STATE OF HAWAII DEPARTMENT OF TRANSPORTATION HIGHWAYS DIVISION	
INDEX TO DRAWINGS	
RAMP-IF	
STA: 78+17.13 TO STA: 85+37.69	
AIRPORT INTERCHANGE	
F.A.I. PROJECT No. I-HI-1 (174)16	
SCALE: N.T.S.	DATE: SEPT. 1982
SHEET No. I-1 OF 42 SHEETS

Contract Change Order No. 2 - Footing 30F Revision

STATE OF HAWAII DEPARTMENT OF TRANSPORTATION HIGHWAYS DIVISION	
REVISED FOOTING 30F DETAIL	
RAMP IF	
AIRPORT INTERCHANGE E.A.I. PROJ. NO. I-HI-1 (174) 16	
SCALE: AS SHOWN	DATE: JULY, 1983
SHEET NO. 8A OF SHEETS

HINGED BEARING DETAIL
RAMP-1F
STA: 78+17.13 TO STA: 85+37.69

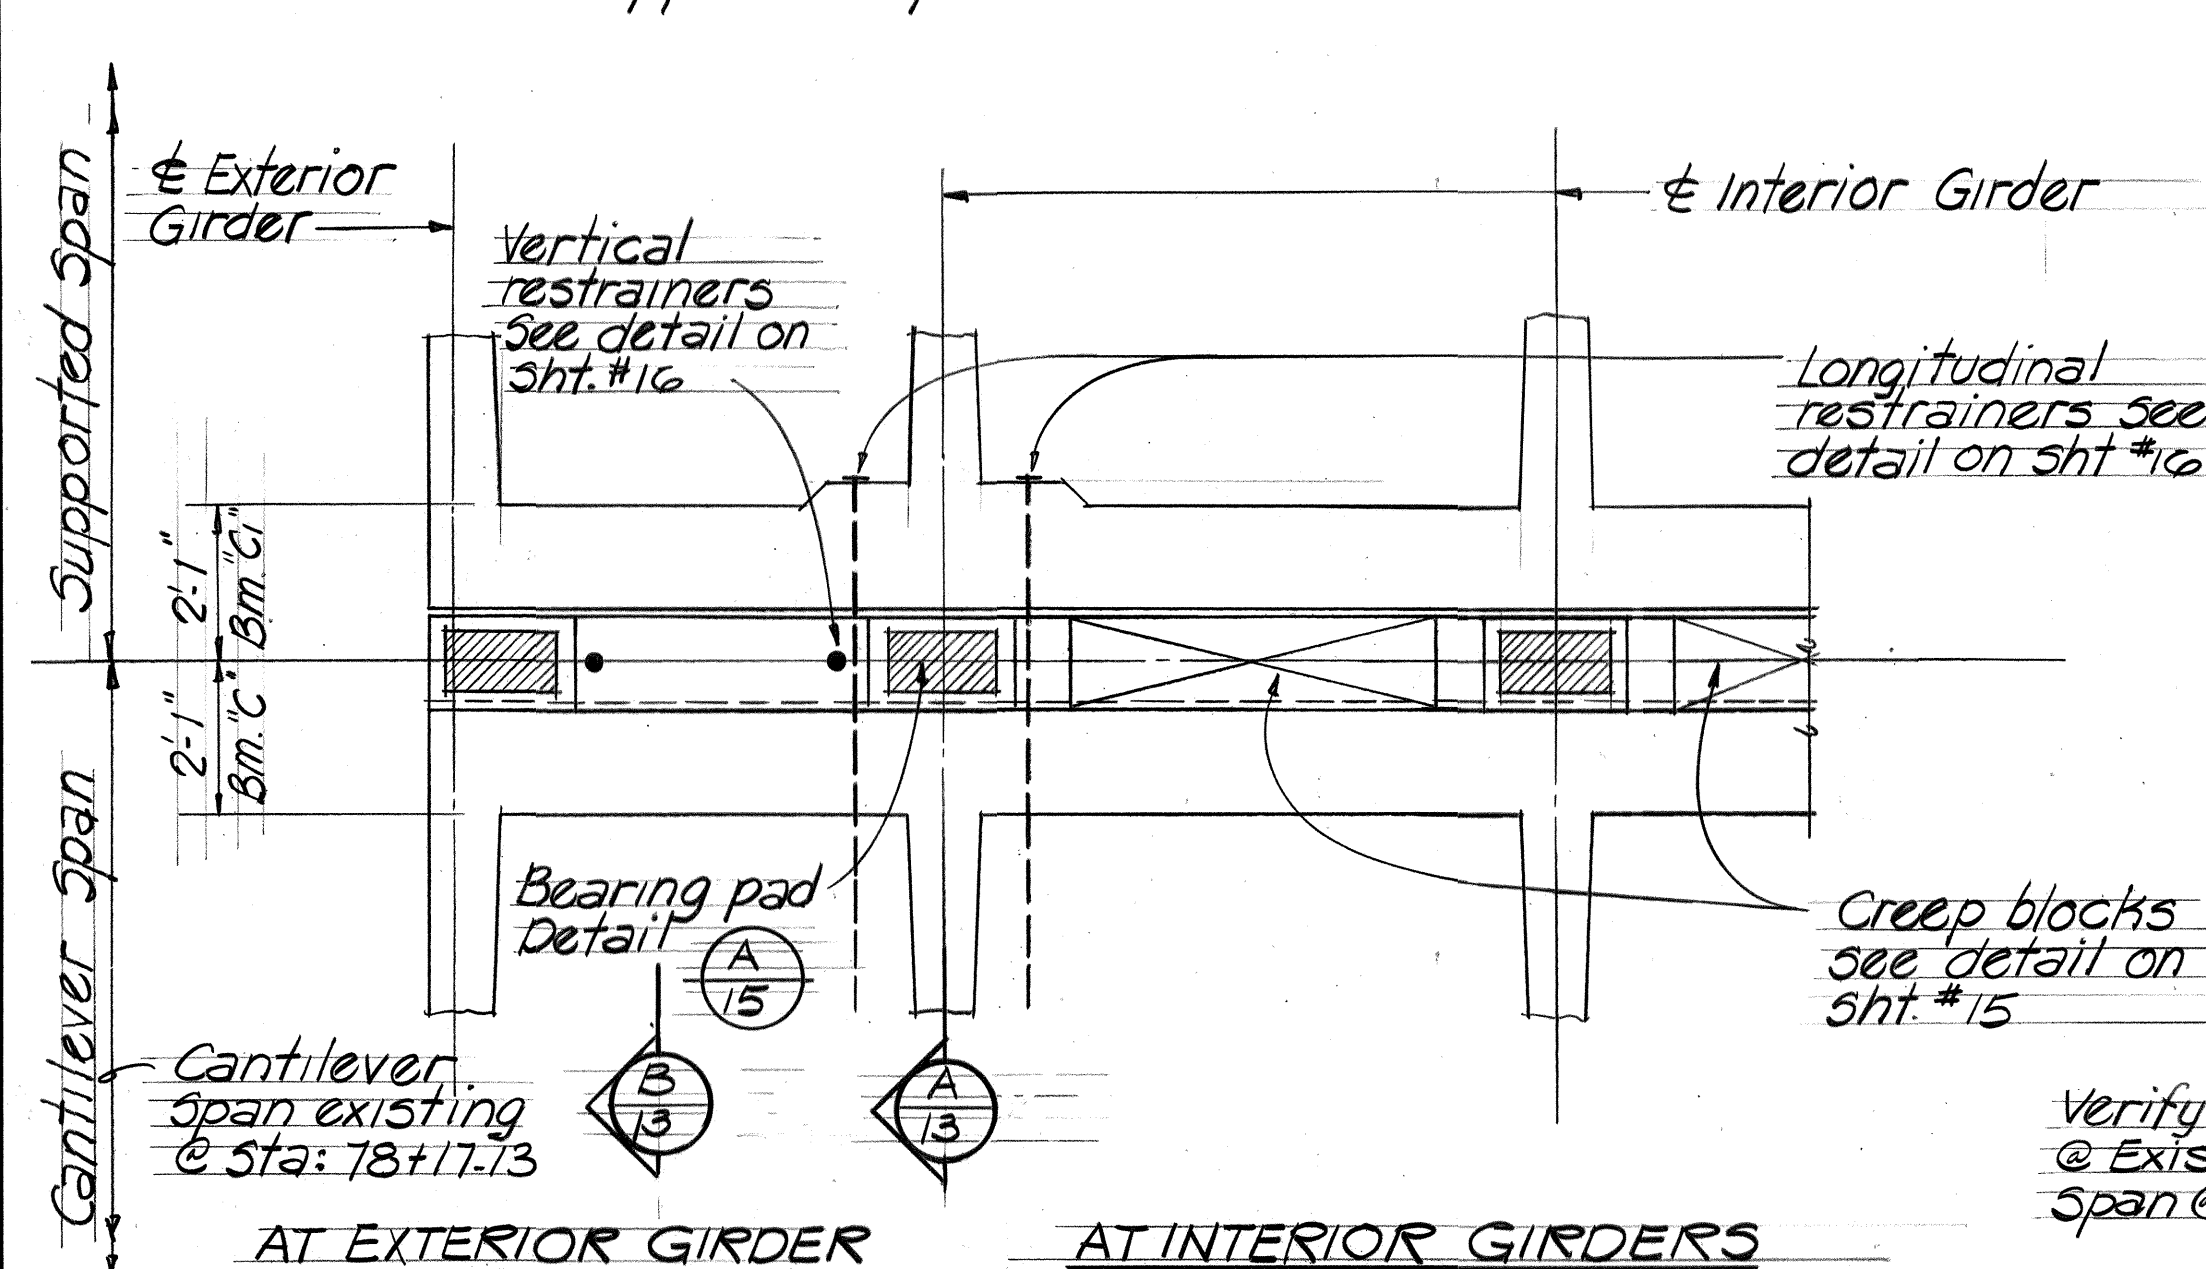
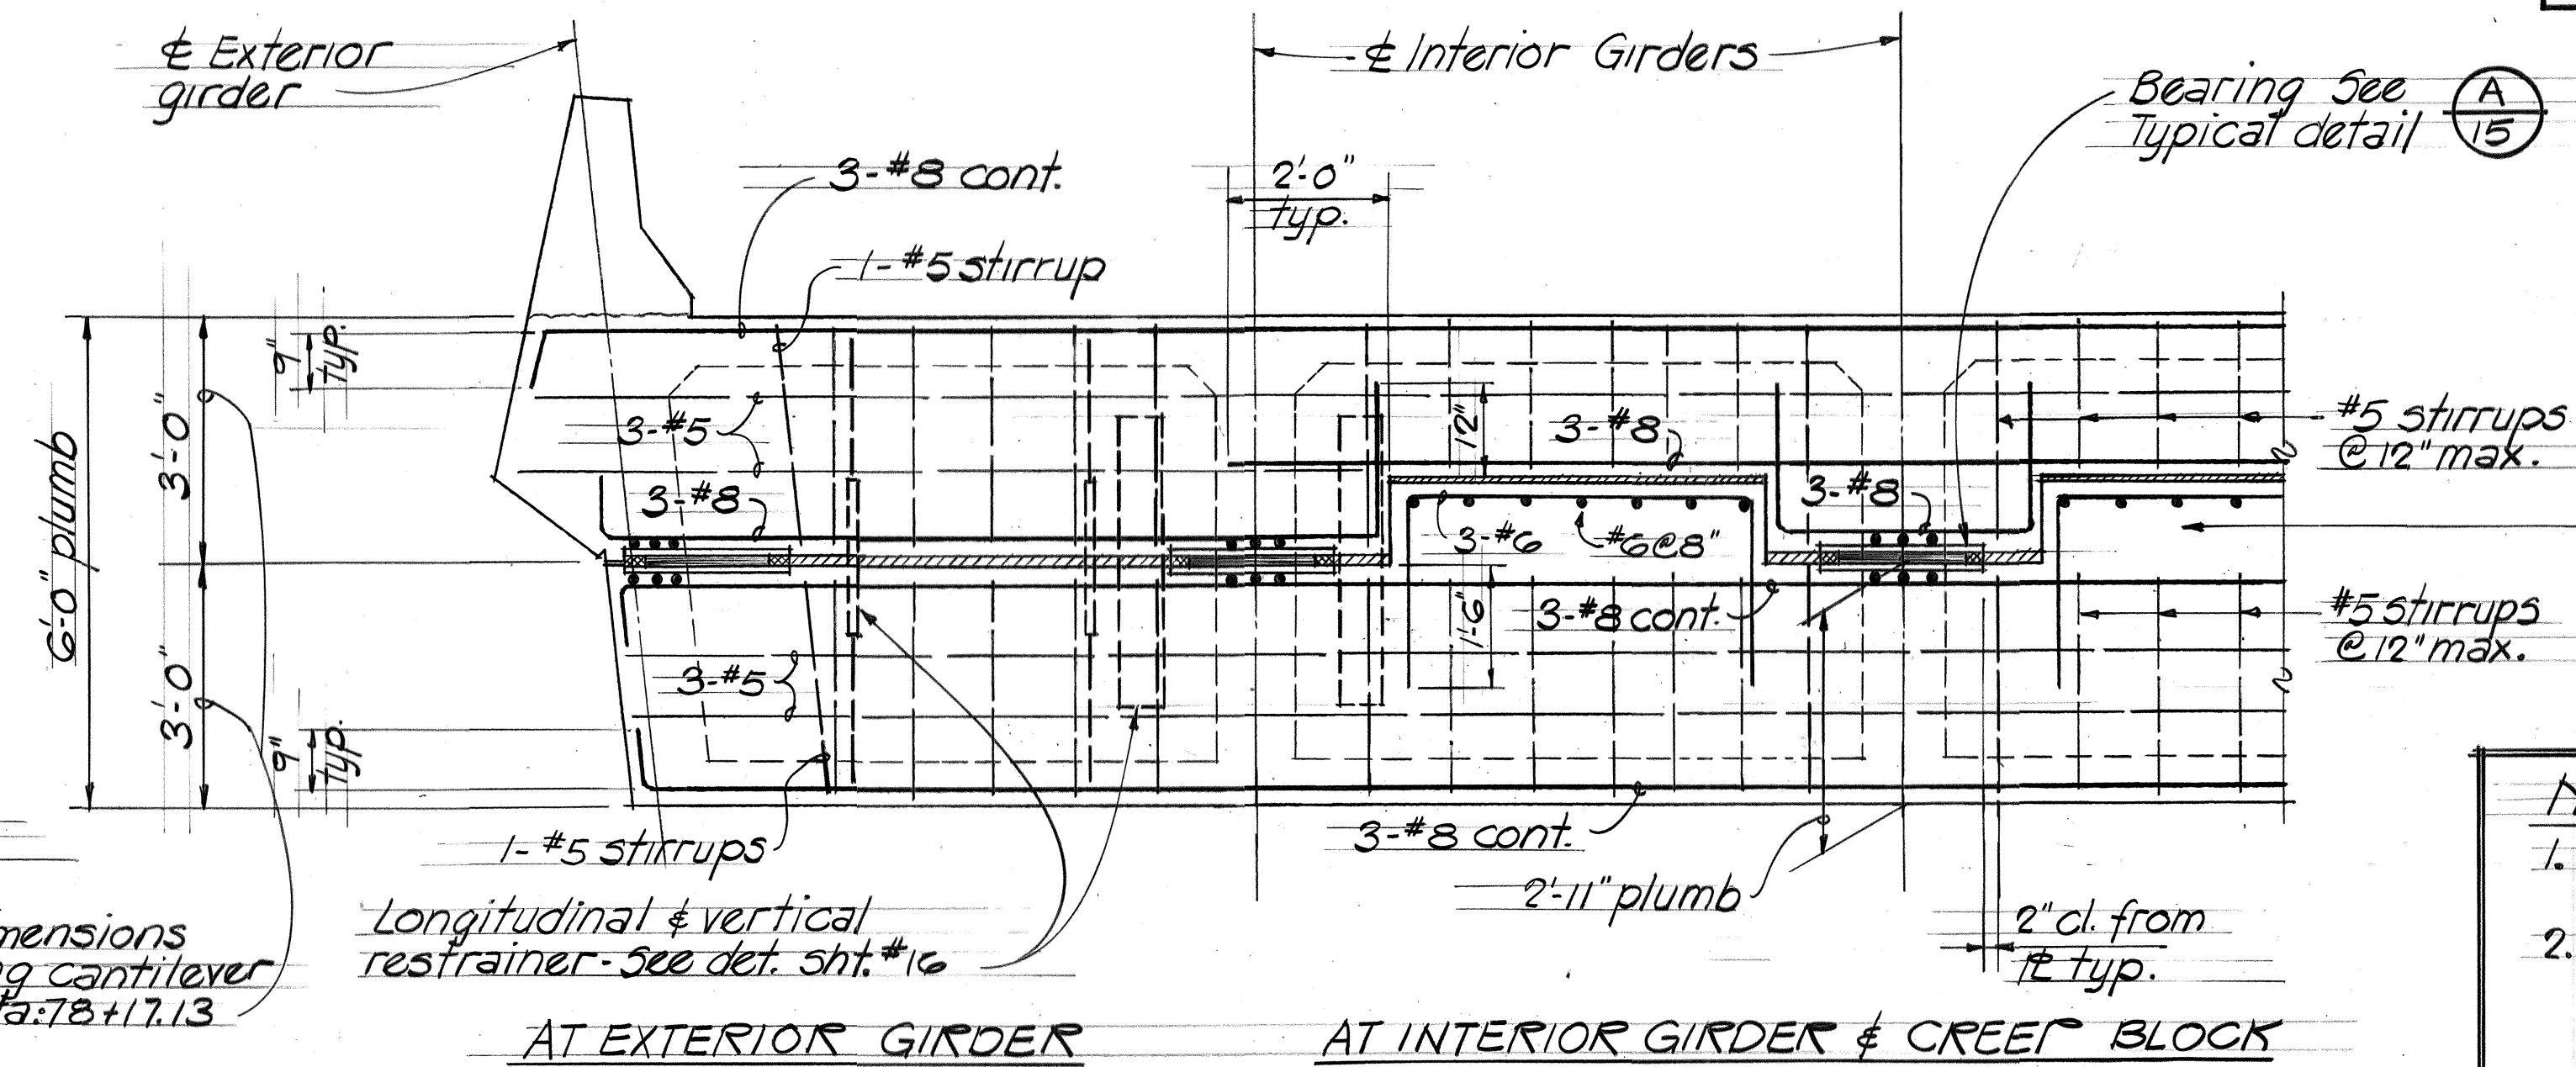
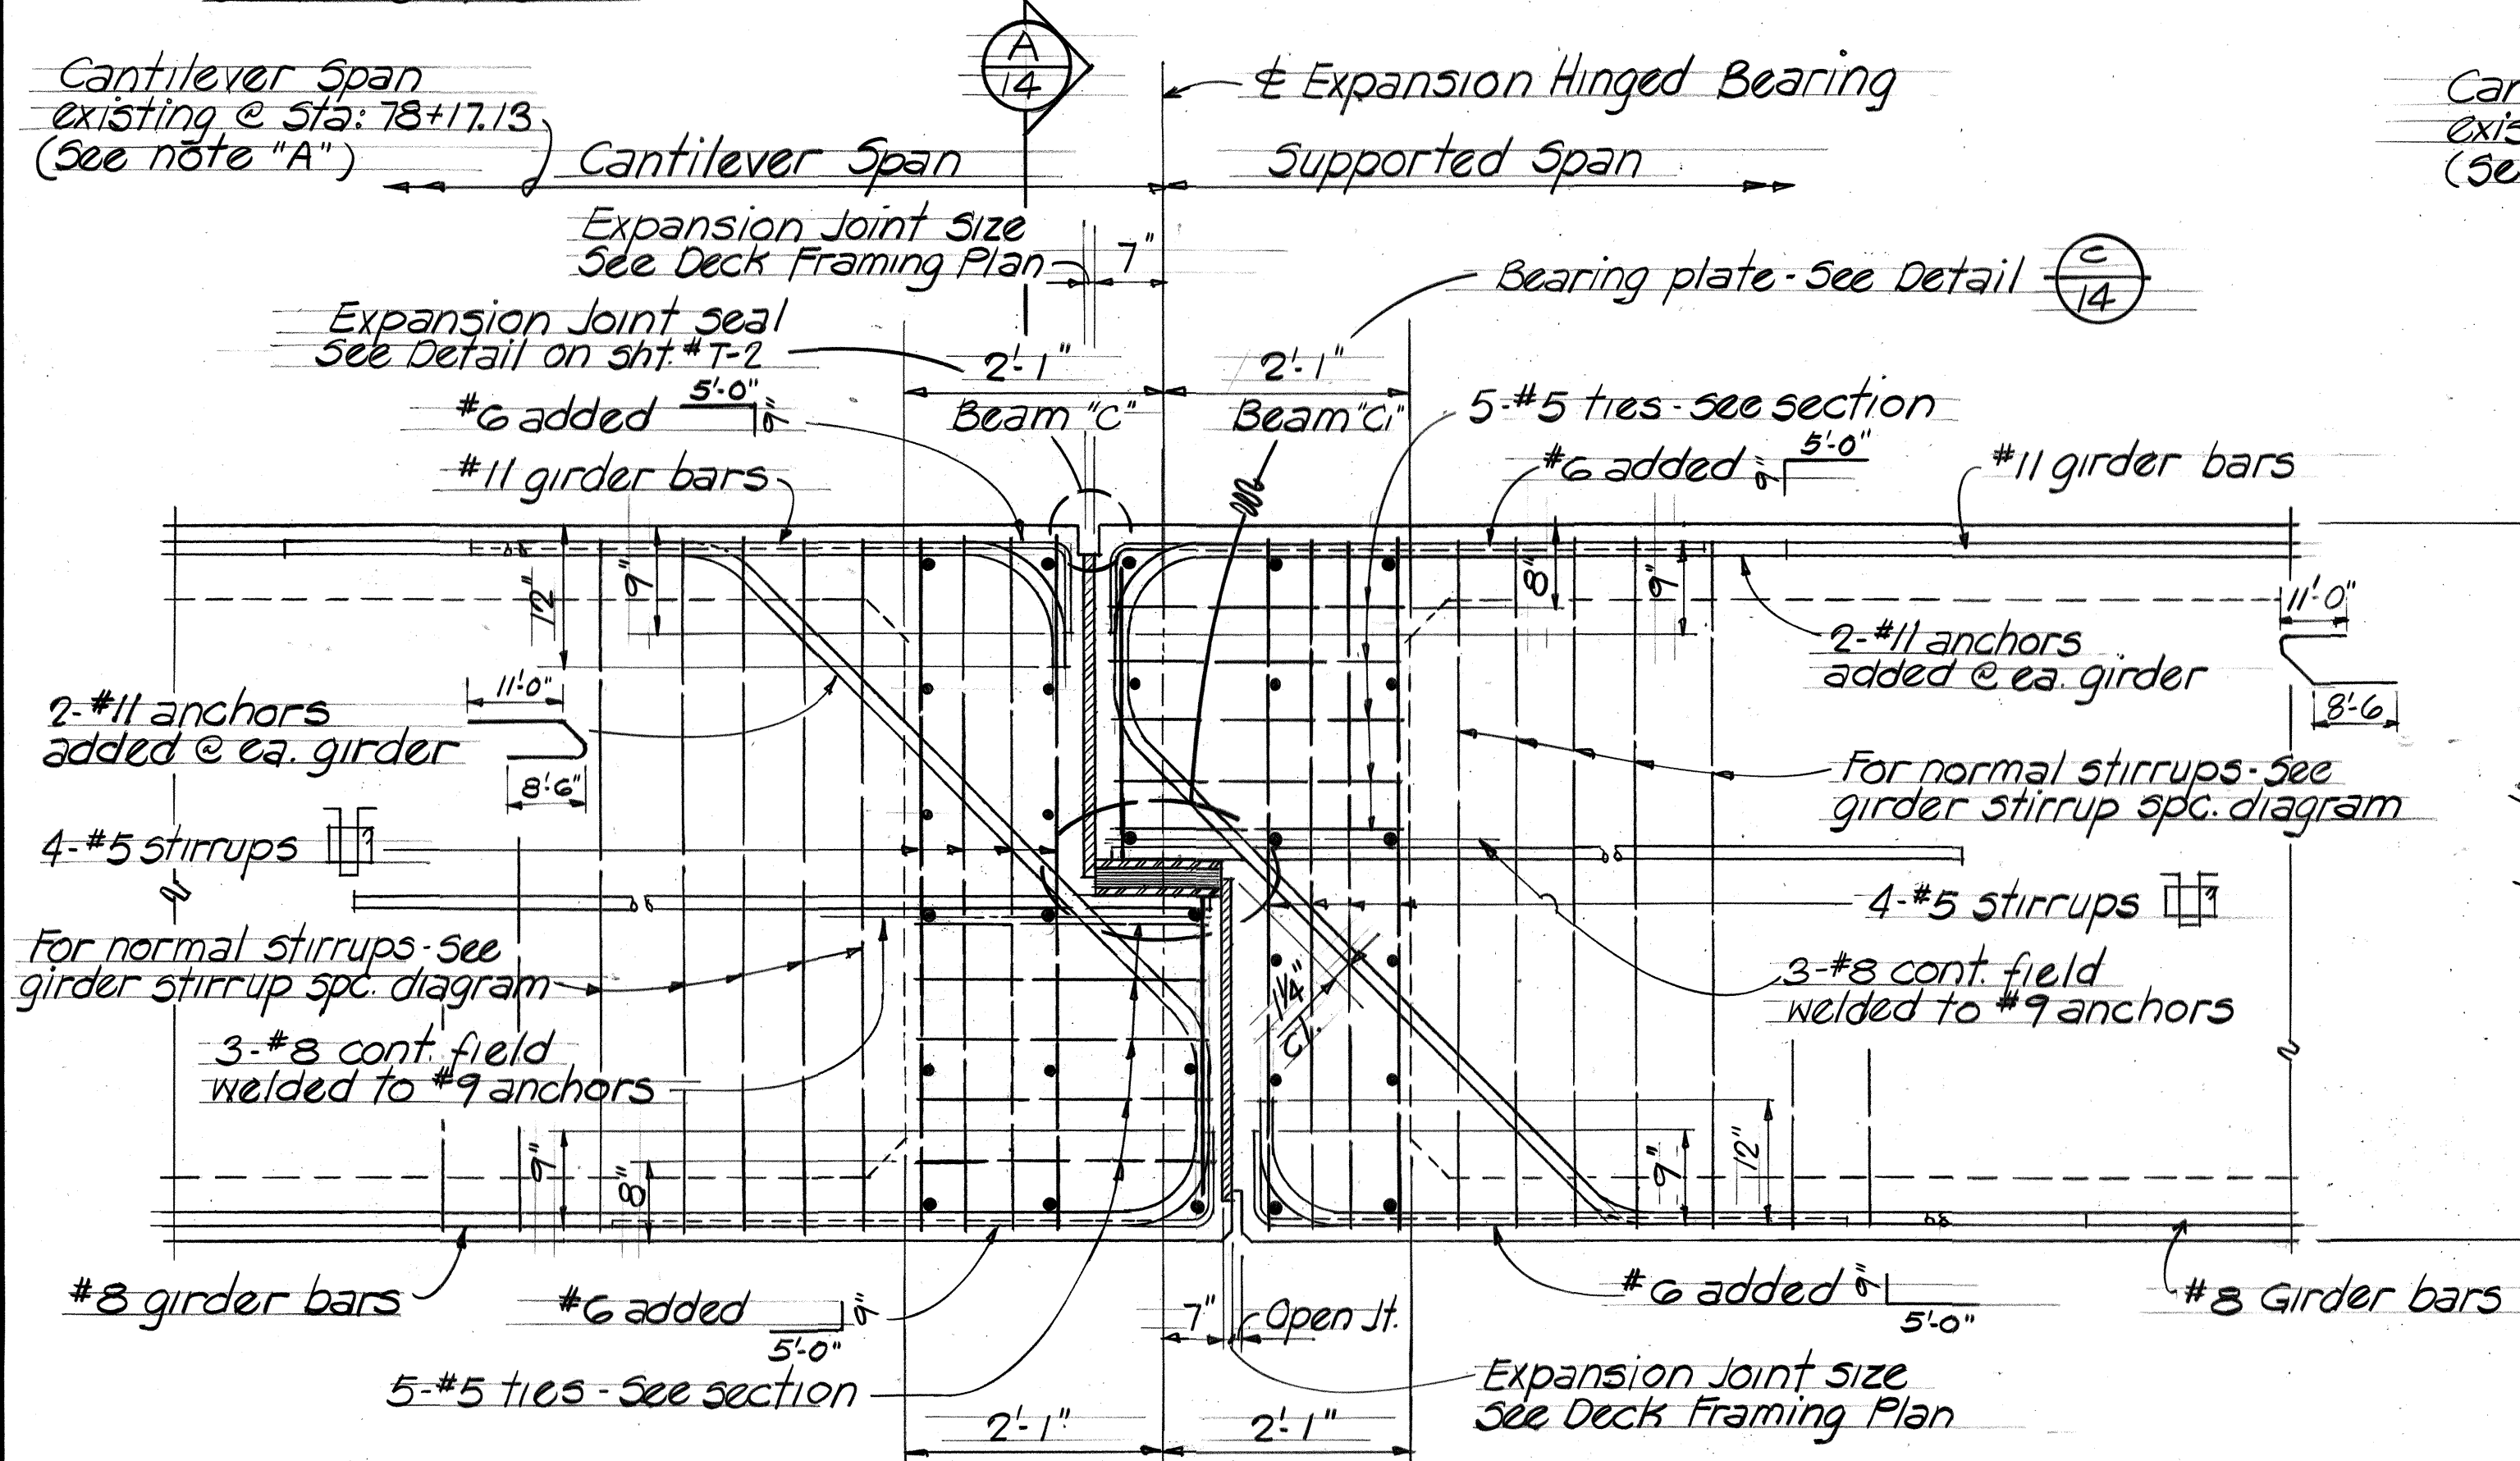
See C.C.O. No. 5 on Sht. 33.
